DATE: October 16, 2017

RE: Revised City of Colorado Springs Driveway

The City of Colorado Springs, Engineering Department, has issued revised Standard Driveway Details effective October 16, 2017.

DRAWING NO. D-16A

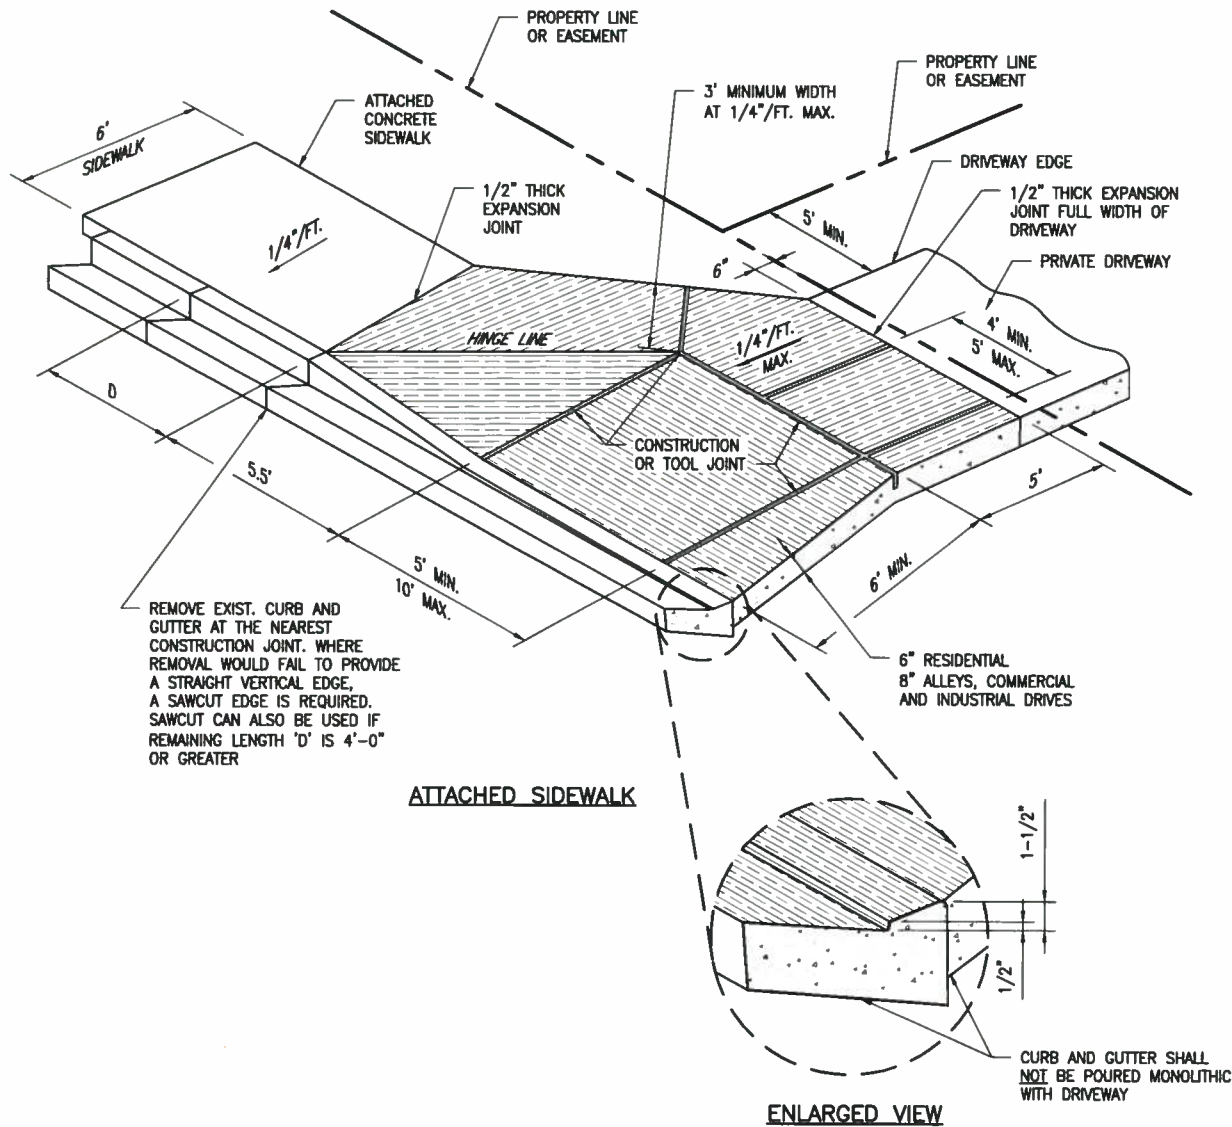
Changes to the Standard Details include the addition of reinforcing steel for commercial/industrial driveways. Electronic copies of these revised details are available on the City of Colorado Springs, City Engineering Standard Drawings page:

1. ALL ALLEYS, COMMERCIAL, OR INDUSTRIAL DRIVE ENTRANCES REQUIRE 8" REINFORCED CONCRETE TO INCLUDE CURB AND GUTTER, WITH #4 REBAR AT 18" O.C.E.W.
2. ALL TOOL JOINTS SHALL BE A MINIMUM OF 1-1/2" DEEP.
